# Hoffmann Drilling Pty Ltd Superannuation Fund v Gold Coast City Council & Ors

## Planning and Environment Court Appeal No 137 of 2020

Joint Expert Report on groundwater issues between Dr Trevor Johnson (TJ) of SLR Consulting, acting for Hoffmann Drilling, Tony McAlister (TM) of Water Technology acting for Gold Coast City Council and Dr Matthew Currell (MC) of RMIT acting for the Australian Rainforest Conservation Society from a joint experts meeting held via email between 16 and 23 October 2020

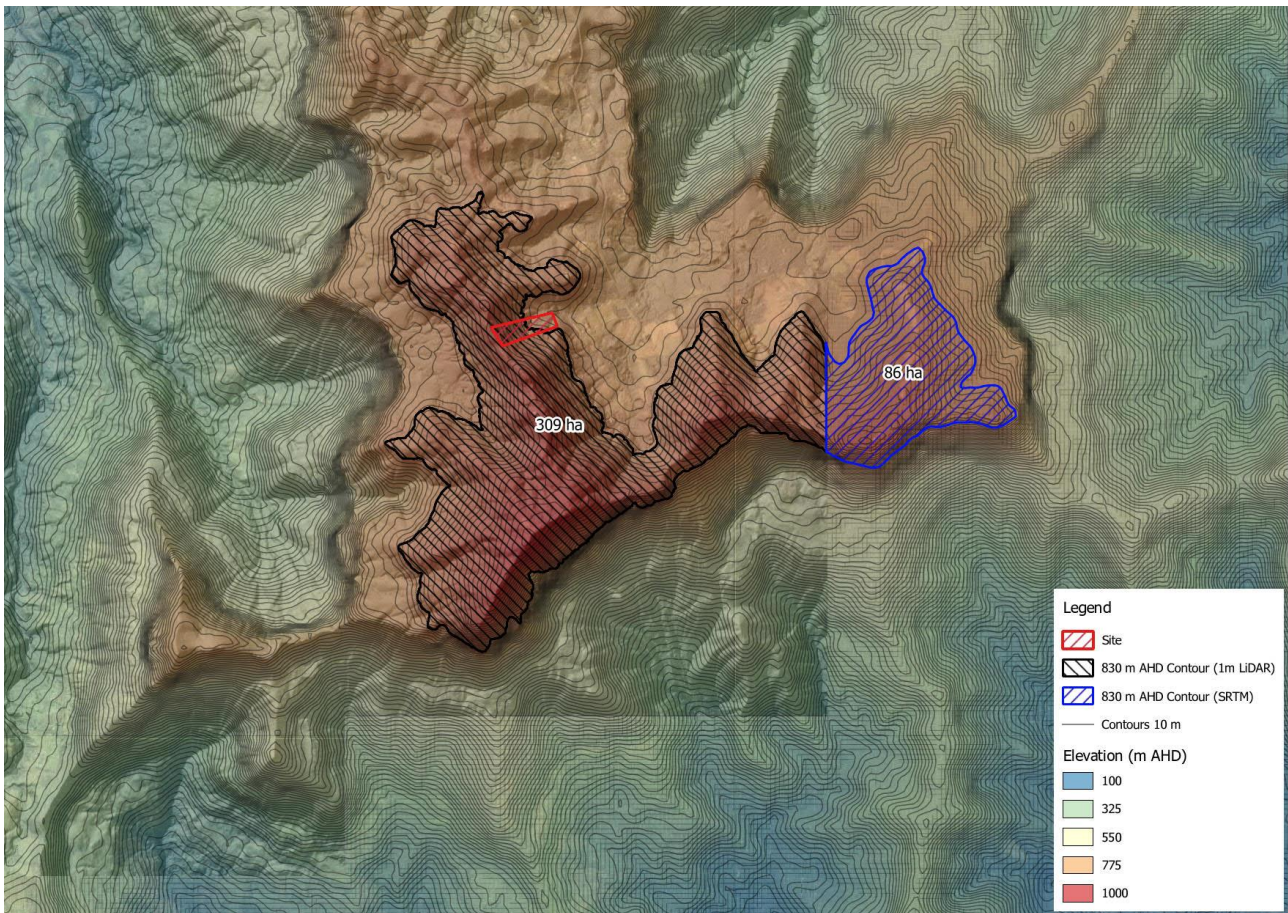
- 1d TJ states that there is only way to determine the catchment area, and this is to trace around the 830 m AHD contour on a topographic map of the area. Please see the following image which shows the extent of the 830 m AHD contour. It is clear and unremarkable that seepage occurring on this area following rainfall will flow into the aquifer. TJ does not understand the "alternative" methods employed by TM to estimate the catchment area. TJ also notes that the SLR response in respect of preparing a water balance model was in accord with discussions held between TJ and Mr Craig Flavel of Water Technology, who was Council's expert at the time. The catchment area adopted by SLR consulting is shown following. It is noted that the analysis is conservative in that we have terminated the catchment area used in the analysis to exclude about 86 ha of the area above 830 m AHD in the far east of the map.

- 1e. MC notes the analysis above and believes that the connectivity between recharge occurring over the region above elevation of 830m AHD shown in the map, and the aquifer in which the production bores are installed, is not demonstrated. He believes it cannot be assumed that recharge above this elevation occurs across this full area or that it infiltrates into a connected aquifer system in which the bores are installed, without first mapping groundwater elevation contours and documenting the hydrogeological characteristics of the area in more detail.

- 1f. TM is of the same opinion in regard to this matter as MC and used what he considers to be reasonable judgement in calculating his effective catchment area.

Figure 2 – Site photographs with location map shown. Supplied to MC by Australian Rainforest Conservation Society.

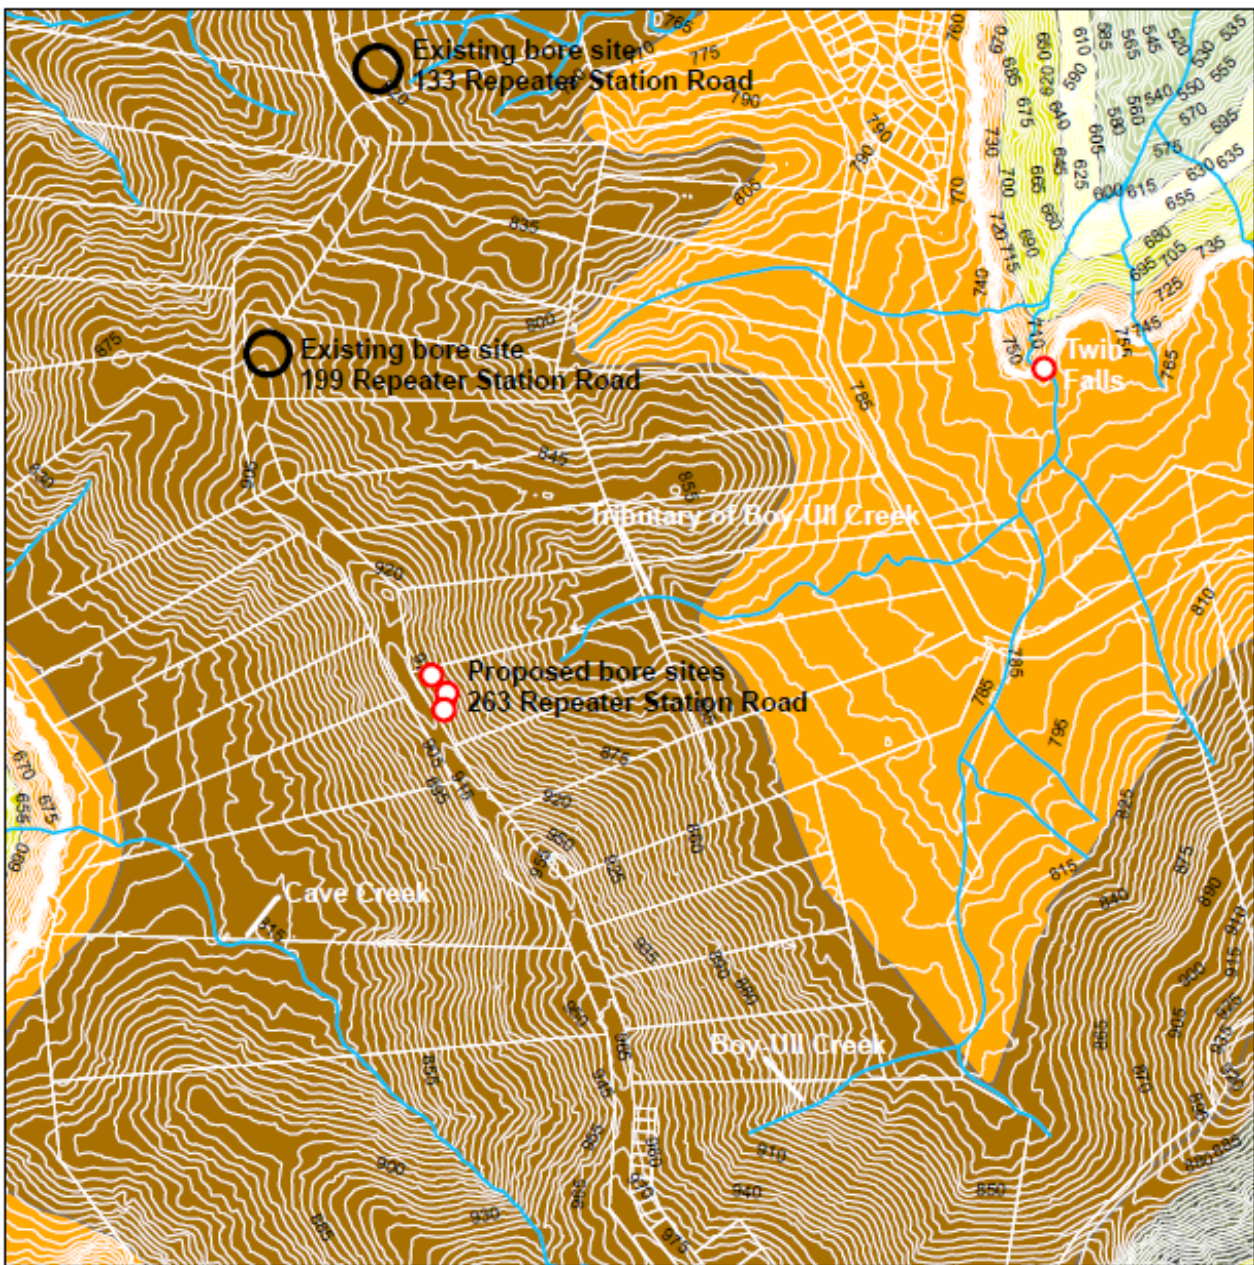
5c MC says that he has seen photographs indicating a number of locations where groundwater appears to discharge to the surface in the vicinity of the bores (see Figure 2 below), and this groundwater may be ecologically important. MC says that the stream network and topographic maps of the site (Fig. 1 & Figure 3, below) also show that springs or seeps of discharging groundwater east of the bores appear to flow to Twin Falls, while those to the west flow to Cave Creek, which sustains Natural Bridge. These are sites of high environmental significance which have a high likelihood of being impacted by reduced flows in response to the proposed groundwater extraction.

5d TJ says that there is no disagreement with MC about either the existence or location of springs on the Hoffmann site, and he fails to understand what point MC is trying to make. The springs observed on the Hoffmann site are all consistent with the nomination of a groundwater level of about 830 m AHD in the aquifer. It is expected that there will be surface expression of water below this level, as evidenced by the MC photographs.

Figure 4 – Annual rainfall totals from Springbrook Forestry and Upper Springbrook monitoring stations from 1950. Data supplied by Australian Rainforest Conservation Society.

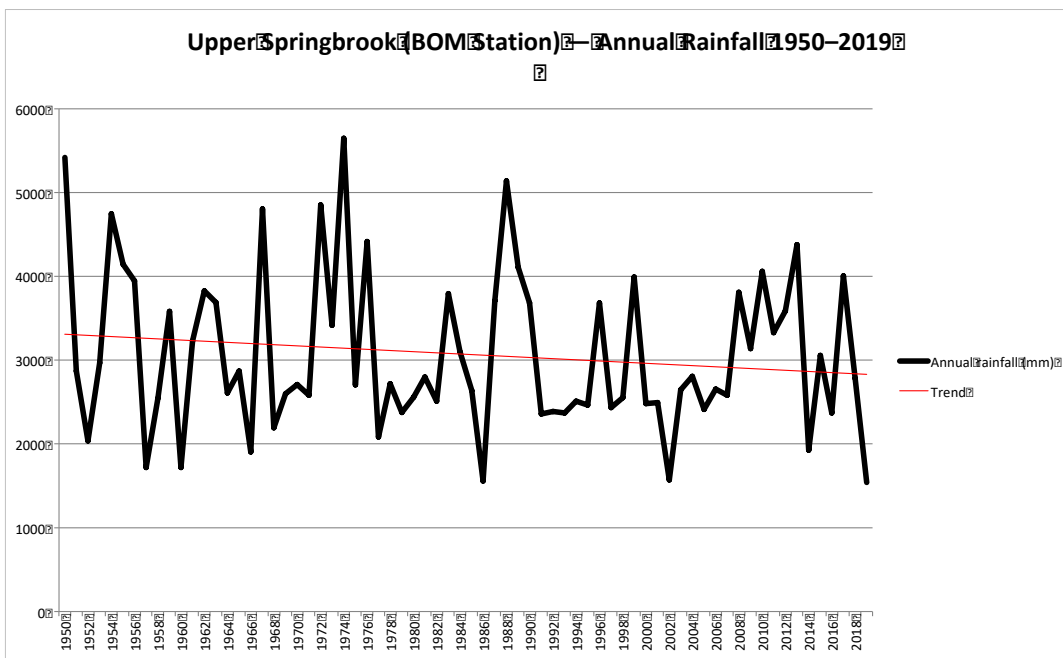
- 20a MC says that according to data from the Springbrook Forestry and Upper Springbrook rainfall gauging stations, annual rainfall has been declining since 1950 (see Figure 4 below), and there is a strong likelihood this will continue in coming decades.

20b TJ does not agree with this conclusion based on the records for Springbrook Road since 1981, as represented by the following Bureau of Meteorology graph. This shows no long term consistent trend since 1985, although it is accepted that recent years have been relatively dry. However, it is also apparent that the period from 2009 to 2013 was wetter on average.

Figure 5 – Climate modelling predictions from the Queensland Government’s Long Paddock Queensland Future Climate Dashboard (Skytus et al., 2020)<sup>3</sup>

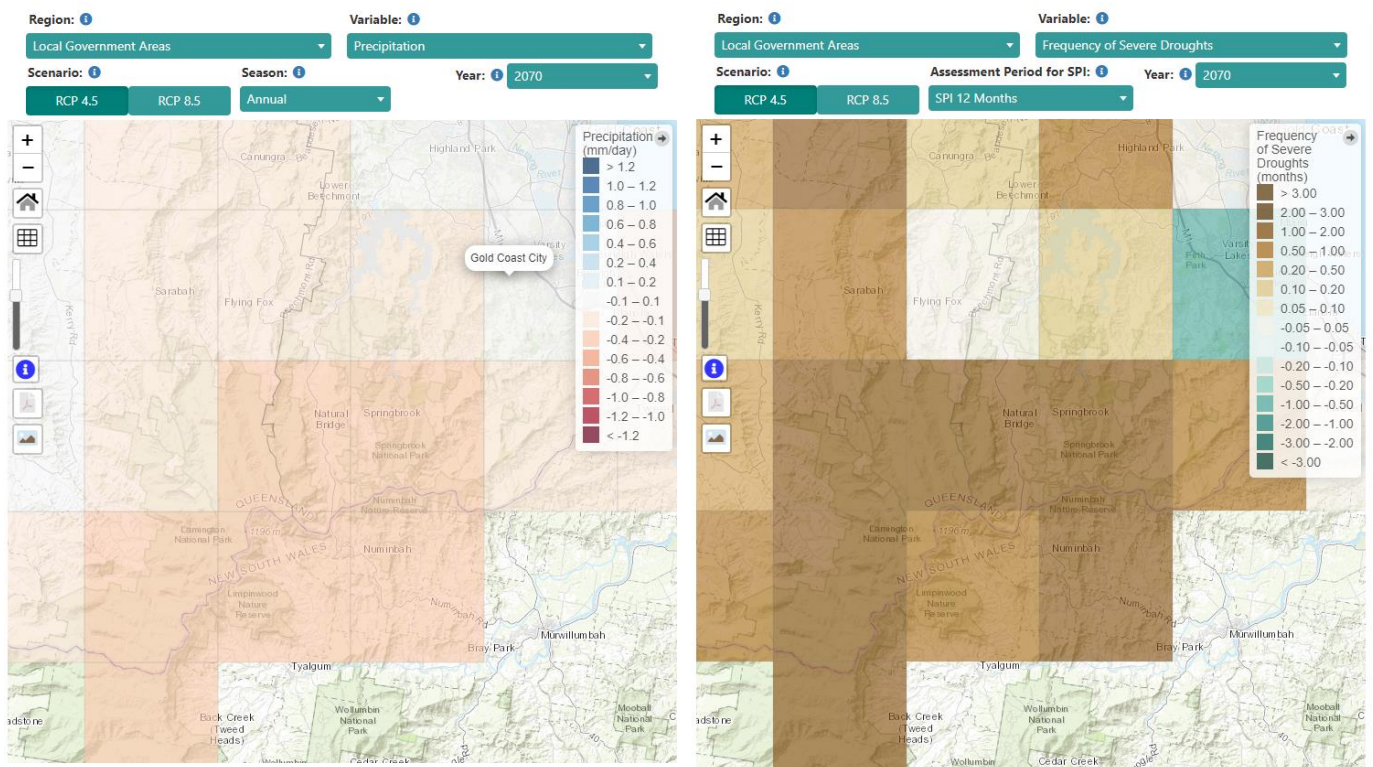
21a MC notes that the Queensland Government’s *Future Climate Dashboard* predicts that by 2070, under the RCP4.5 and 8.5 global emissions trajectories, Springbrook is predicted to experience:

- A decrease in daily precipitation (Figure 5)
- Increase in frequency of severe and extreme droughts (Figure 5)
- Increase in duration of droughts

MC believes these climate predictions must be considered when assessing the impacts of the proposed development, along with a close analysis of the cumulative impacts of the proposed development and the bores at 133 Repeater Station Rd.

- 21b TJ says these are, at best, estimates based on very broad global circulation modelling techniques which have no site specific information relevant to the Springbrook plateau. The Climate Dashboard is one useful tool to consider the potential impacts of climate change. In reality, no-one can state or predict accurately what the future holds in respect of rainfall totals or intensities. On the basis of MC's arguments, no-one should do anything since it might be affected by future climate change. If climate change does impact the ability of this applicant to safely extract groundwater from the Springbrook aquifer, then this will be adequately managed by the imposition and application of suitable conditions of approval including operational monitoring.
